UNT/ UNTS
OAK STREET HALL DEMOLITION &
ART STUDIO FACILITY
1001 W. MULBERRY STREET
DENTON, TEXAS 76201
VAI Project No. 18012.001

ADDENDUM NO. 03
Addendum to Project Manual and Drawings dated November 09, 2020

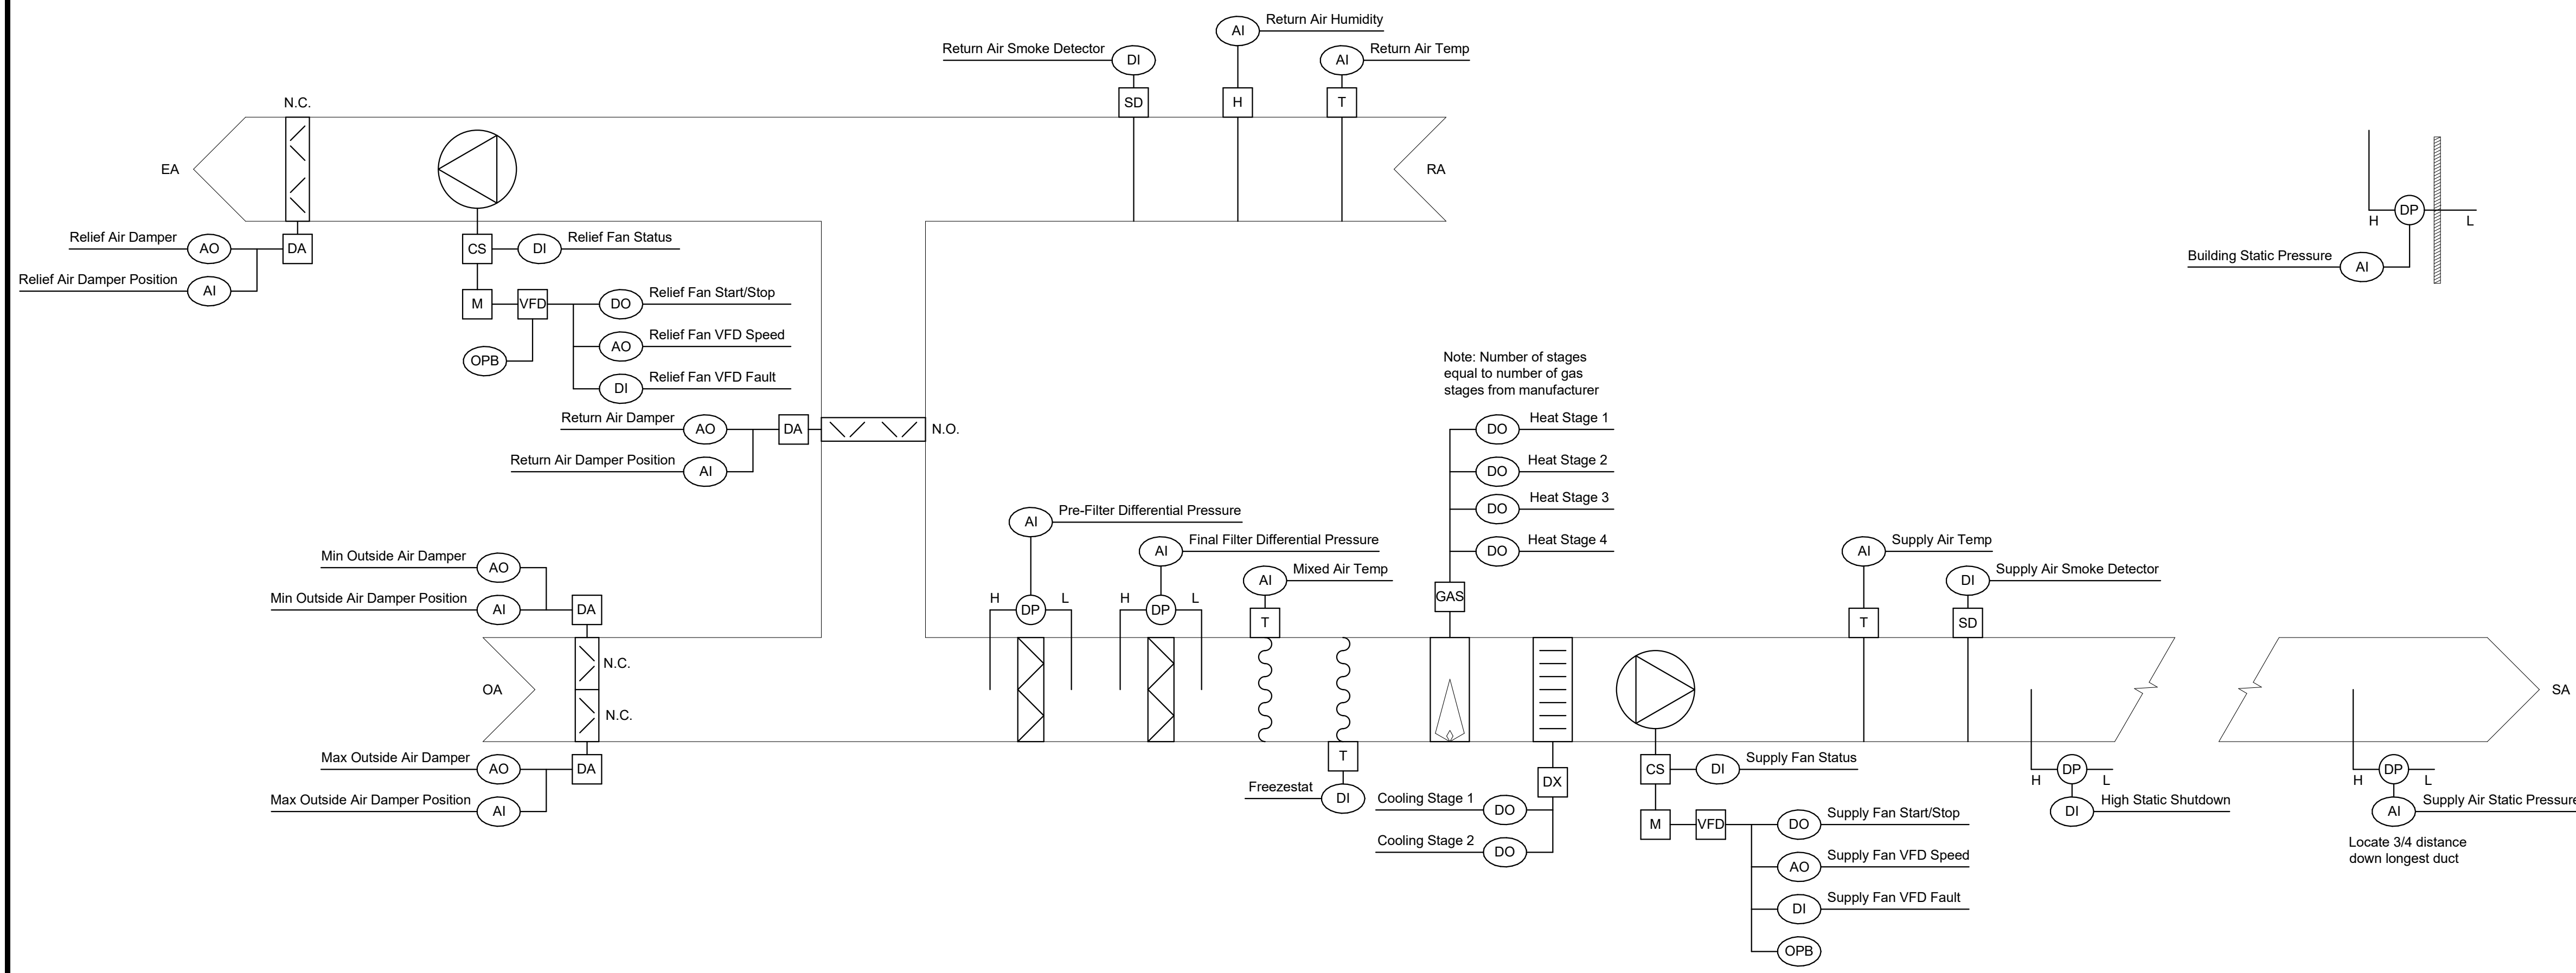
10. Detail references on standing seam roof shows metal panels removable at Kiln Curbs. Please provide detail. The top of the curbs are Mod bit roofing which can easily be replaced. But if the metal roof panels in the middle of a standing seam roof are to be removed we have a problem.

1—specified panel will not work

2- the low slope of the metal panel must have a mechanically seamed panel for a water tight warranty.

3- if panels are removed we would suggest a curb that separates panels or the panels will have to be unseamed and damaged— Please have architect provide more data on what they are trying to achieve

RESPONSE: Reference detail 05 & 06/ A503. The detail notes a prefab. metal roof curb that separates the metal panel roof from the roof cap that is removable.
